March 30, 2022

To: Members of the Nevada County Planning Commission, Nevada County Board of Supervisors, and Nevada County Planning Department Staff

Comments on the Draft Environmental Impact Report for the Idaho-Maryland Mine Project

Figure 4.8-7
Groundwater Movement in Mine Workings (Existing Condition)

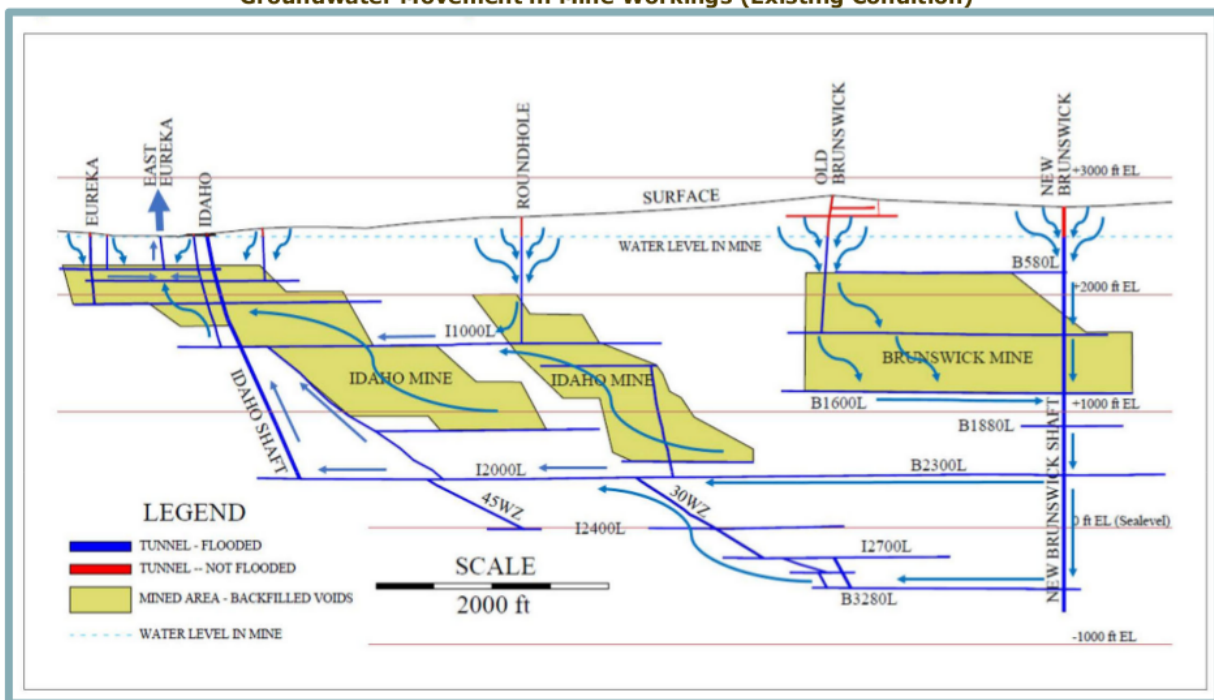
The Hydrology Report (DEIR Appendix K.2, Table 4-10, p120) uses discharge screening limits and data from the New Brunswick shaft to define water treatment criteria. However, a more accurate sampling of mine water would be from the drains located along Wolf Creek rather than from the New Brunswick shaft, as described in the analysis of mine water flow (see DEIR Figure

4.8-7), which shows water entering the New Brunswick shaft then flowing downward through the extant mineworks to exit the drains at Wolf Creek (Eureka drain, East Eureka drain, etc). Only a few samples taken from the drains were reported, but these samples are much more representative of the mine water chemistry and indicate higher levels of Iron, Manganese, Arsenic, Aluminum, and Zinc than the New Brunswick shaft samples (DEIR K.2 Tables 3-6).

In order to get an accurate assessment of the contaminants flowing out of the mine under varying conditions, regular testing must be conducted over time at the Mine drains. The testing must also be conducted seasonally during differing rates of outflow. Moreover, in order to provide the public with a conservative estimate of potential impacts, the DEIR should use the results from the drain samples rather than the New Brunswick shaft, which would show potential water quality impacts from higher level of metals, arsenic and zinc.
